# UNITED STATES PATENT AND TRADEMARK OFFICE

APPLICATION NO.	FILING DATE	FIRST NAMED INVENTOR	ATTORNEY DOCKET NO.	CONFIRMATION NO.
10/670,168	09/25/2003	Gil M. Vardi	S63.2H-12012-US01	2222
23552 7590 04/02/2007 MERCHANT & GOULD PC P.O. BOX 2903 MINNEAPOLIS, MN 55402-0903			EXAMINER HOUSTON, ELIZABETH	
			ART UNIT 3731	PAPER NUMBER
SHORTENED STATUTORY PERIOD OF RESPONSE 3 MONTHS			MAIL DATE 04/02/2007	DELIVERY MODE PAPER

## Office Action Summary

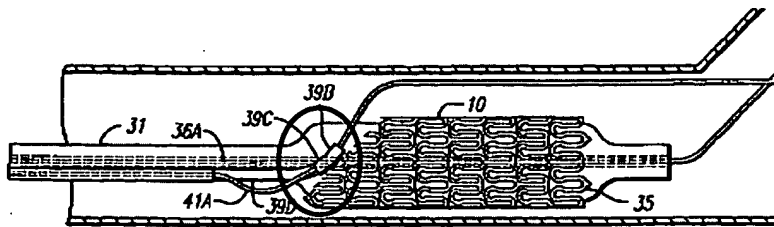
12. Regarding claims 17 and 18, Wilson discloses a distal portion comprising a first and second lumen (39b and 39c) for receiving a first and second guide wires; a proximal tube portion; and a bond portion connecting the proximal and distal portion (see below). The bond portion comprises a three-way bond in that it bonds the shaft with the first lumen and the second lumen. The first and second lumens are attached to

each other (indirectly) along an entire length of the second lumen and only at the bond portion.
